# URBAN DESIGN REVIEW PANEL

590 RIDEAU STREET

JUNE 23, 2016

## RESPONSE TO UDRP COMMENTS

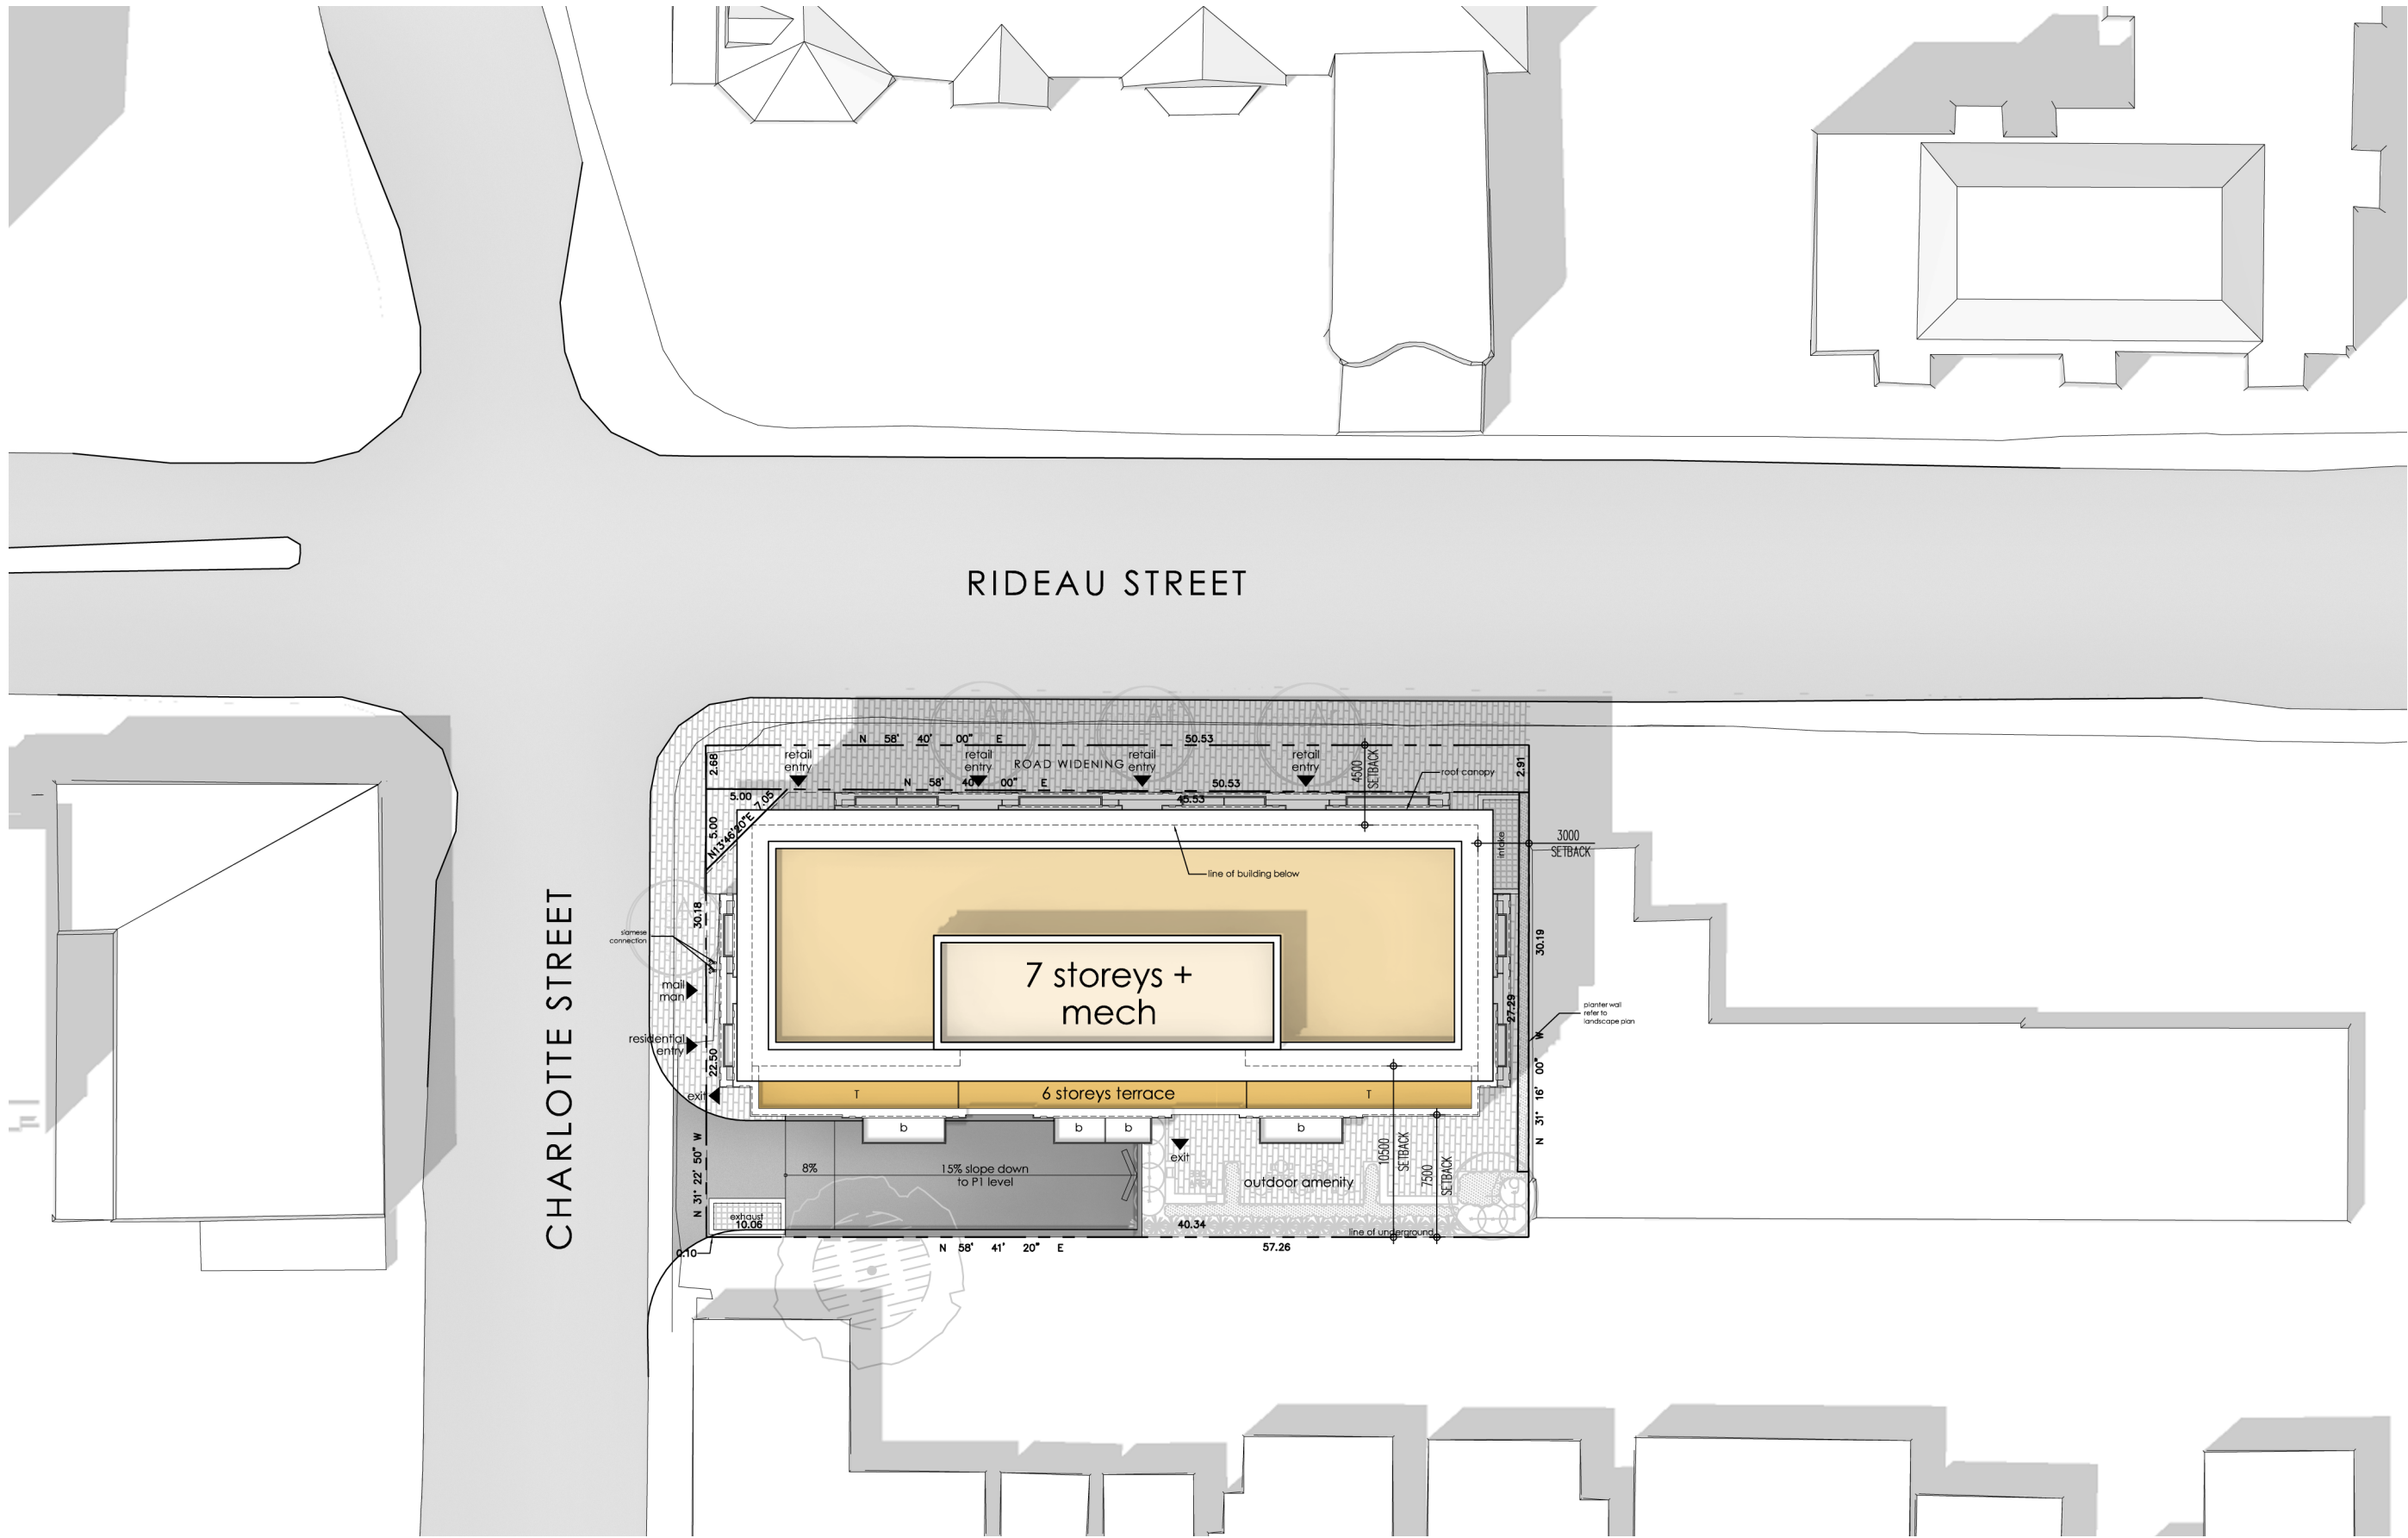
- / The Panel supports the proposal picking up on historic clues of the Wallace House, however recommends either strengthening or weakening this connection in the front façade. The 3:3 proportion of the art deco base and the modern top should be modified so that one of the two vocabularies is dominant.

- / The glass corners of the building along Rideau Street weaken the base and make the white art deco articulation feel like an appliqué. The Panel recommends wrapping the base around the corners of the building, especially at the Charlotte Street corner.

- / The combinations of the whiteness of the Wallace House and of the base of the proposal may change the look and feel of Rideau Street in this area. This may not necessarily be an issue, but it is worth studying.

- / The Panel recommends redesigning the mechanical penthouse so that it is simpler and ties into the rest of the building better.

- / The Panel recommends framing or inseting the floating balconies on the front façade, as they currently contrast greatly with the other balconies.
- / Consider removing the balconies faces east, as they may pose issues with future redevelopment on the adjacent site.

The building design has been revised with a more modern approach with lighter materiality in order to further promote the importance of the Wallace House and to reduce the weight of the building itself. By contrast, the direction to reduce the weight of the materiality has also provided more prominence to the corner feature. The materiality and rhythm of the main structure has been carried through to the mechanical penthouse to simplify the design and have it better tie into the building.

More predominant framing was included around the proposed balconies to better integrate them within the building, while also strengthening the vertical rhythm of the building. The balconies to the east were maintained as it was determined that they provided more value for residents and were required in order to better meet the amenity space requirements of the development.
